In-Flight Icing Encounter and Loss of Control, Simmons Airlines, d.b.a. American Eagle Flight 4184, Avions de Transport Regional (ATR) Model 72-212, N401AM, Roselawn, Indiana, October 31, 1994, PART II

VOLUME II: RESPONSE OF BUREAU ENQUETES-ACCIDENTS
TO SAFETY BOARD'S DRAFT REPORT

Abstract: Volume II contains the comments of the Bureau Enquetes-Accidents on the Safety Board's draft of the accident report. The comments are provided in accordance with Annex 13 to the Convention on International Civil Aviation. Volume I of this report explains the crash of American Eagle flight 4184, an ATR 72 airplane during a rapid descent after an uncommanded roll excursion. The safety issues discussed in the report focused on communicating hazardous weather information to flightcrews, Federal regulations on aircraft icing and icing certification requirements, the monitoring of aircraft airworthiness, and flightcrew training for unusual events/attitudes. Safety recommendations concerning these issues were addressed to the Federal Aviation Administration, the National Oceanic and Atmospheric Administration, and AMR Eagle.

FIGURE 2 : FLIGHT 4184 CVR TIME HISTORY

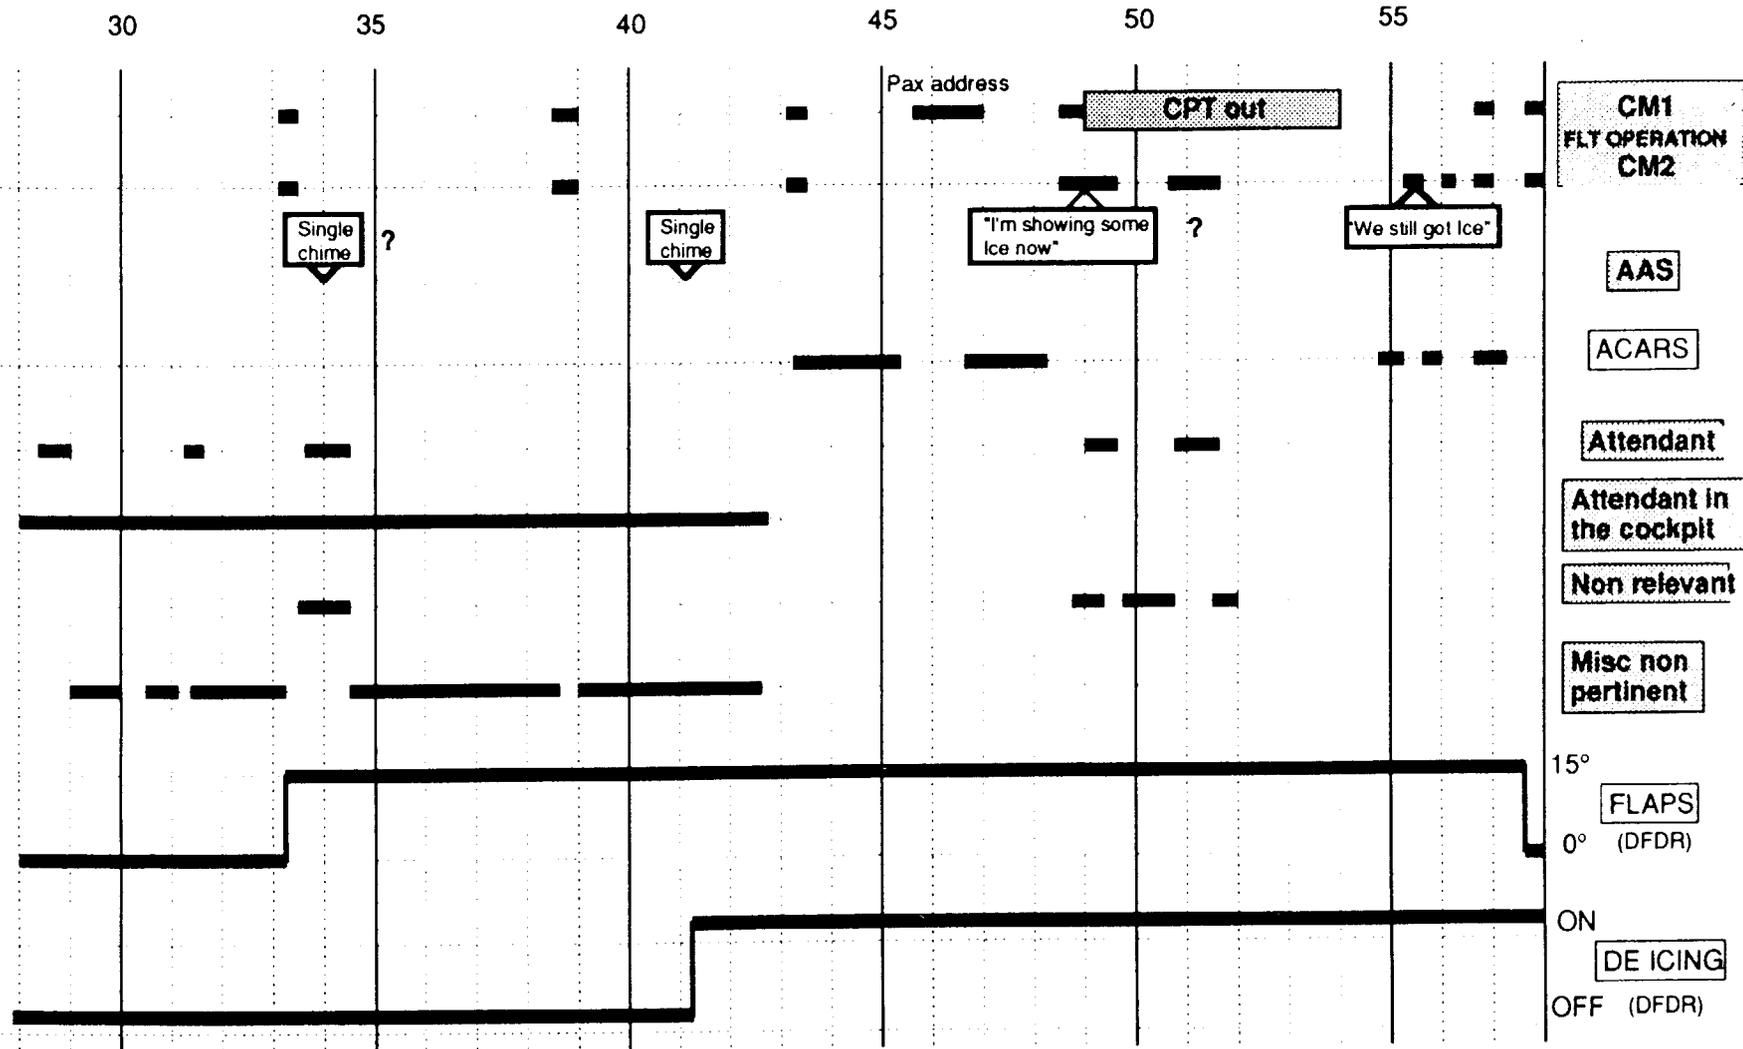
Flight 4184 CVR transcript by NTSB was highly unedited

FIGURE 4 : FLIGHT 4184 SECOND HOLDING PATTERN TIME HISTORY

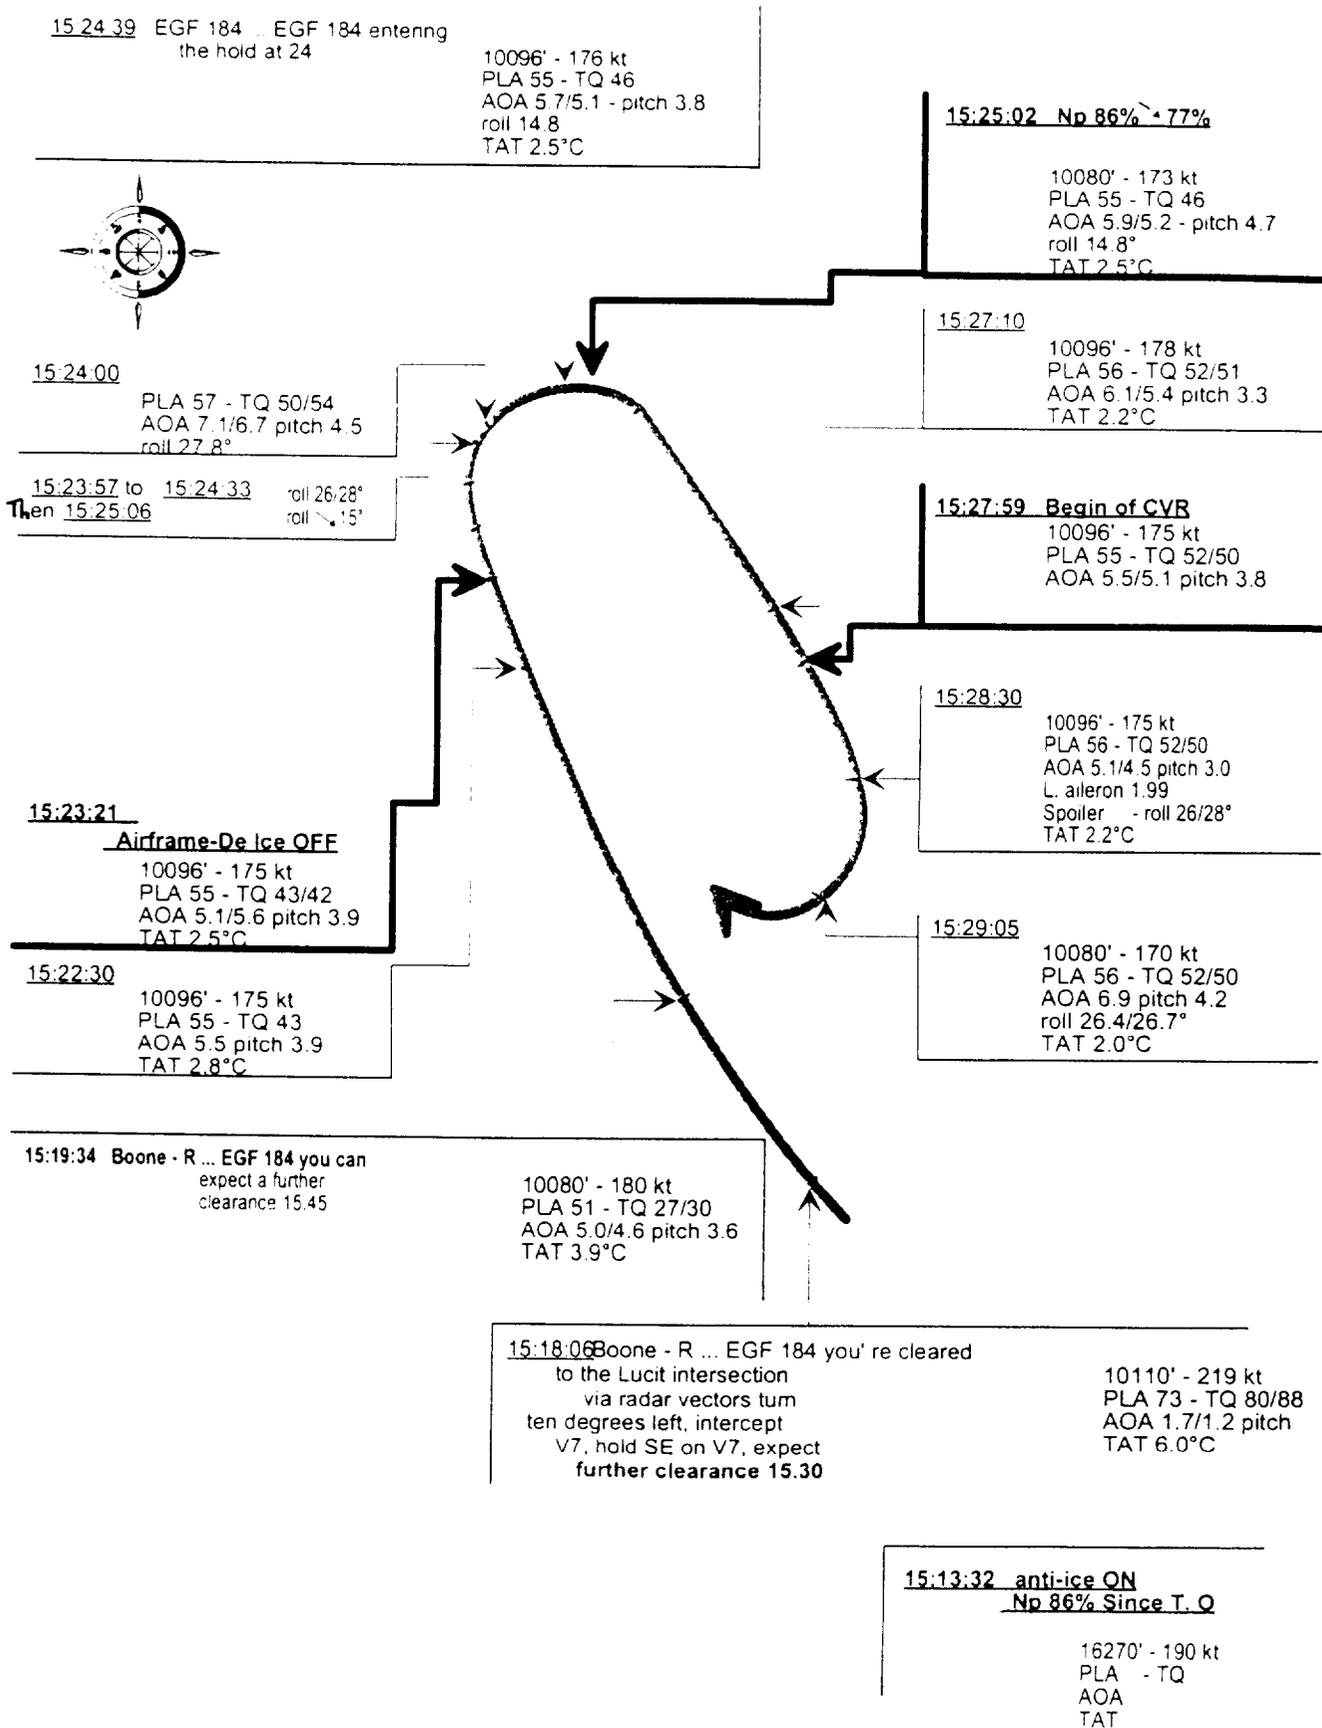
Fm 15:33 to 15:33:28 flaps 15° AOA 7.0/6.1 TO 1.6/1.0

FIGURE 14 : FLIGHT 4184 CVR TIME ANALYSIS

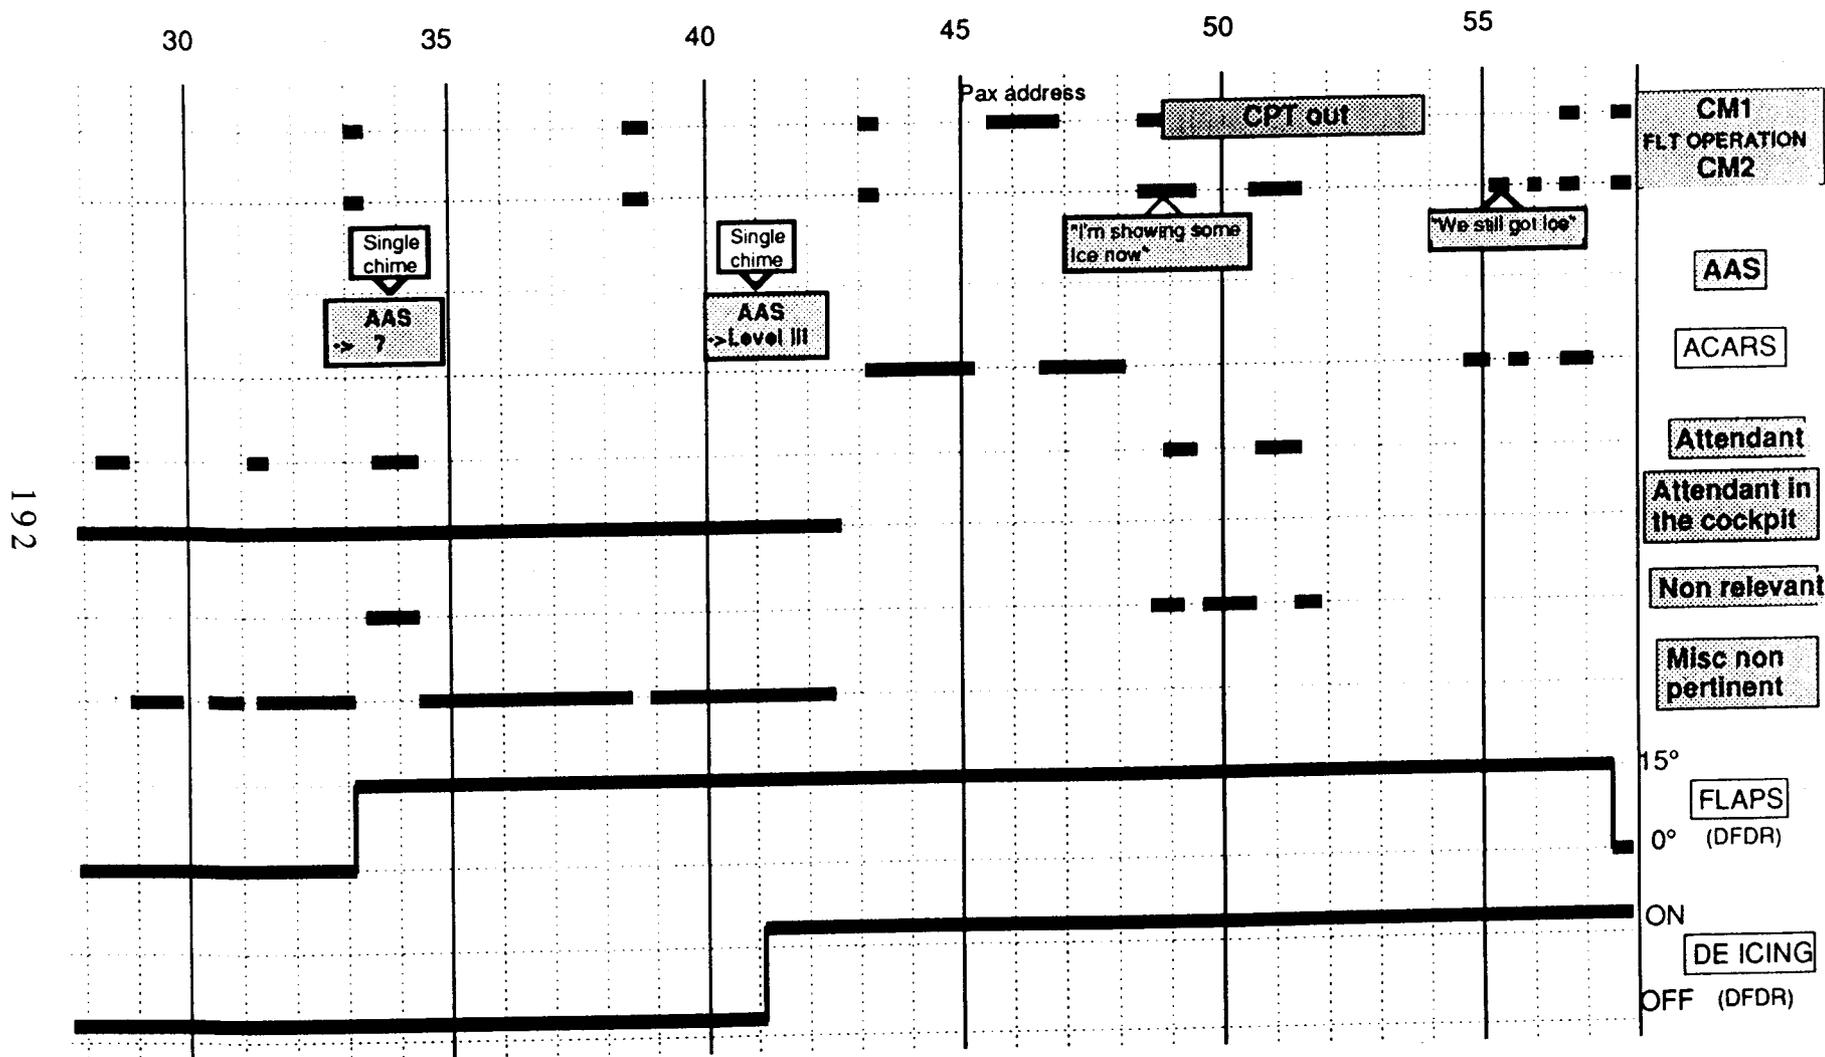
More than 15 mn of Non Relevant & Non Pertinent conversations

FIGURE 16 : PITCH CONTROL INPUTS / ACTIVITY AFTER ROLL UPSET

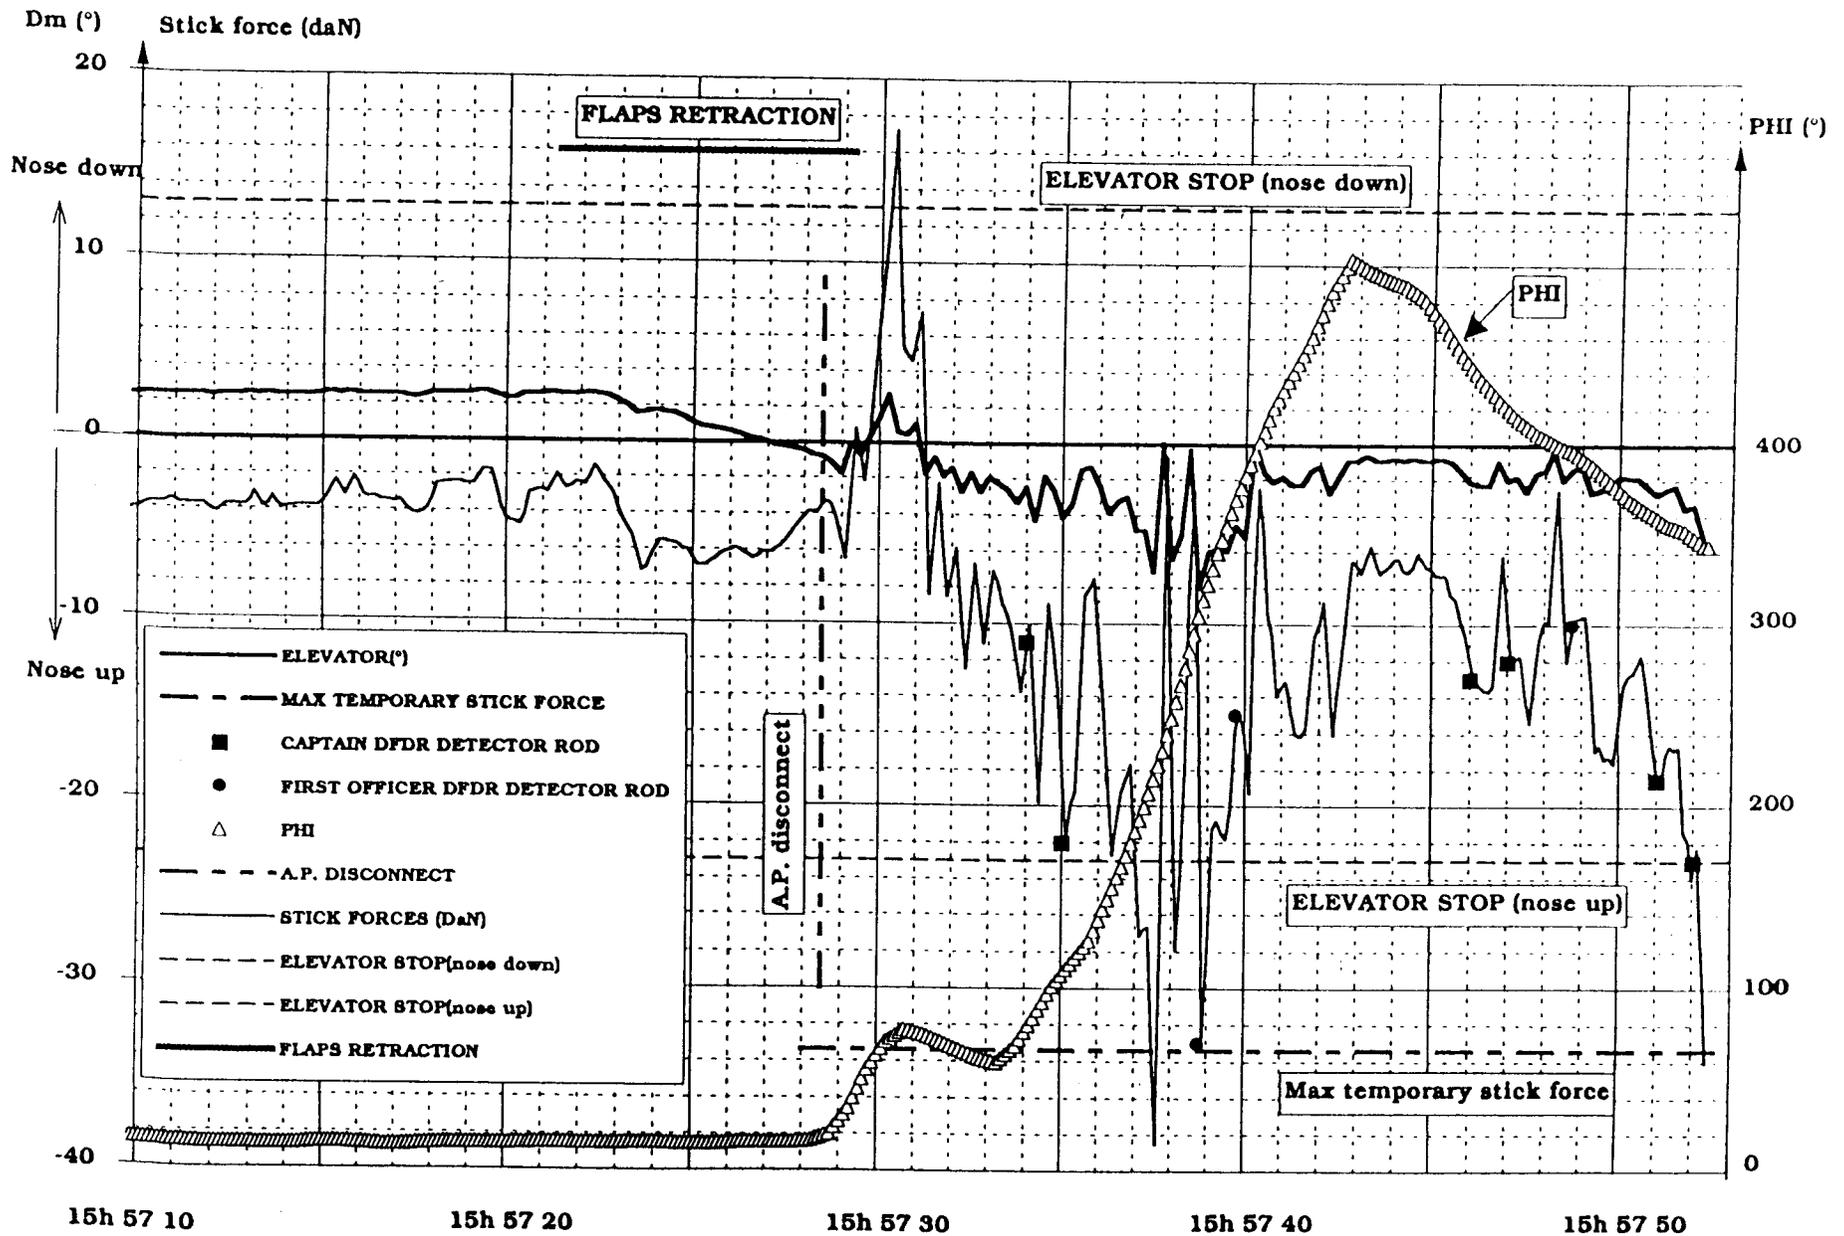
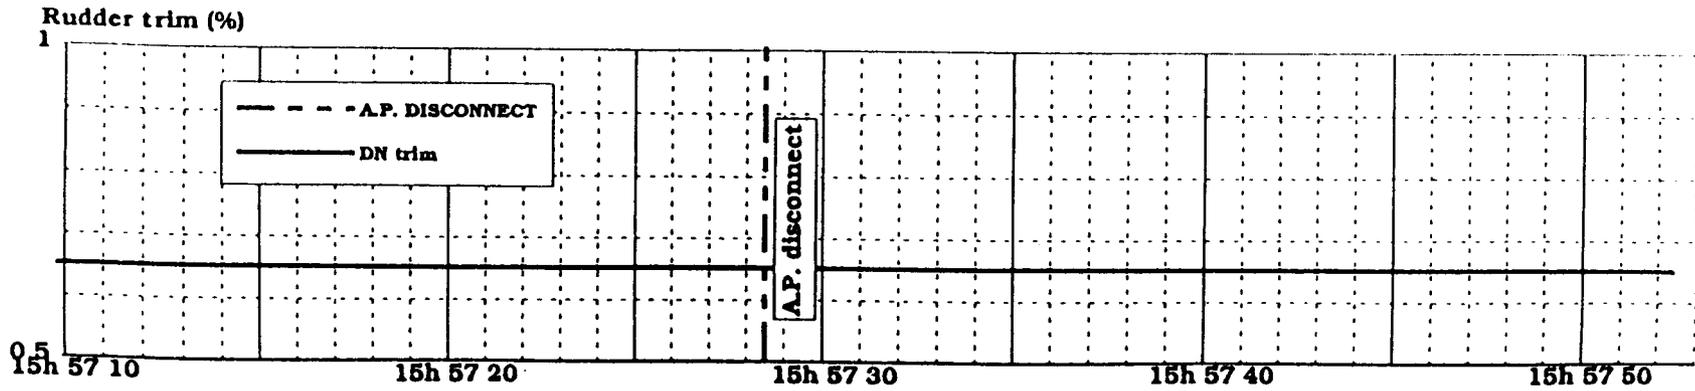
A limited control activity mainly during inverted flight

FIGURE 19 : RECOVERY CAPABILITY THROUGH CONSTANT ROLL INPUT

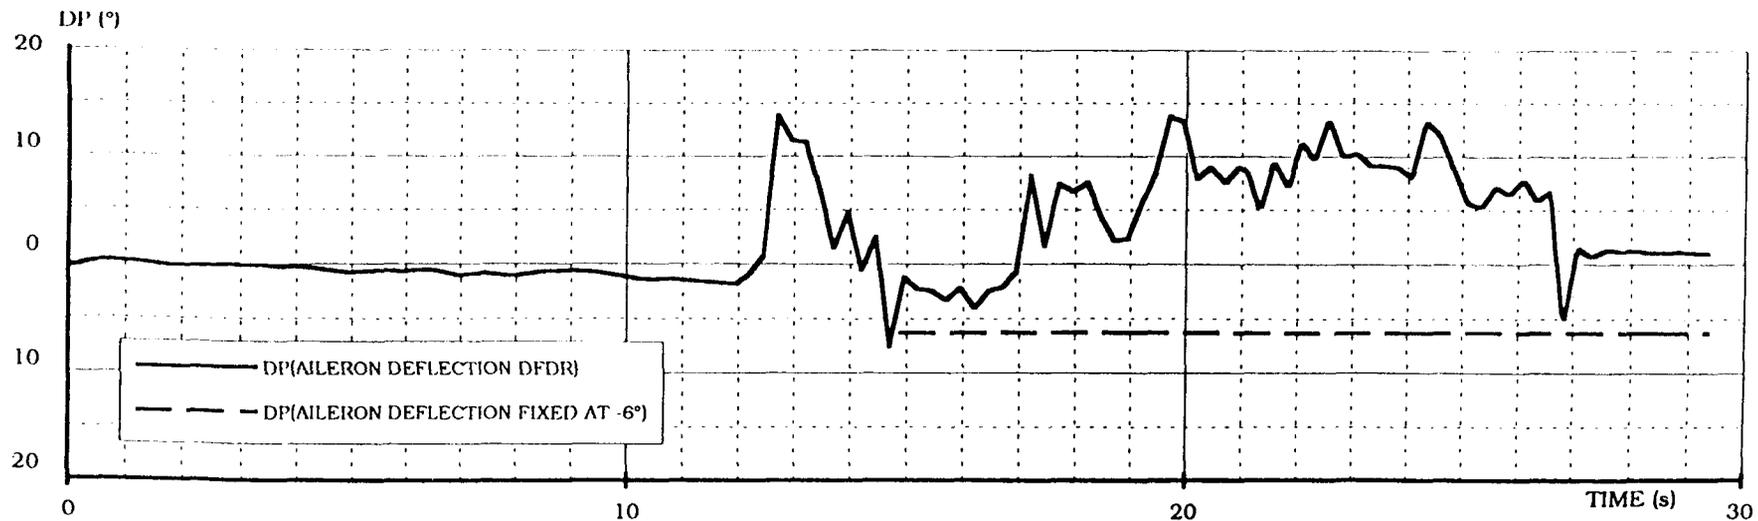
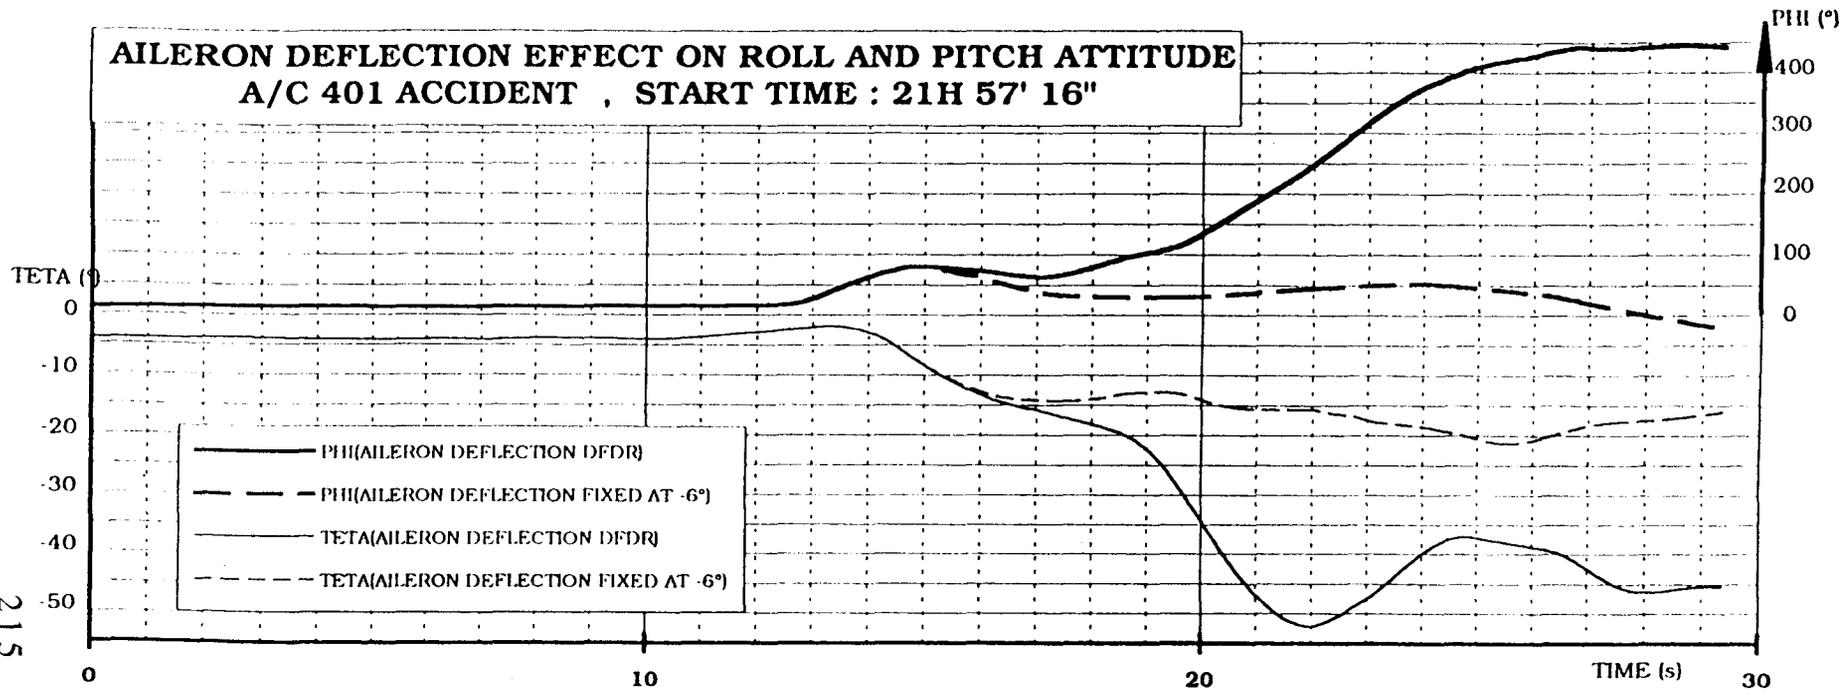
Moreover, assuming a counteracting steady deflection limited to 6° on the ailerons and applied after the maximum conventional crew reaction time used in cruise (3 seconds) after disconnection, the Flight path is rapidly controlled (fig. 19). The lateral attitude is kept close to wings level and the longitudinal attitude does not exceed 22° before returning to 0° .

A constant 6° roll input after 3 sec would allow for recovery
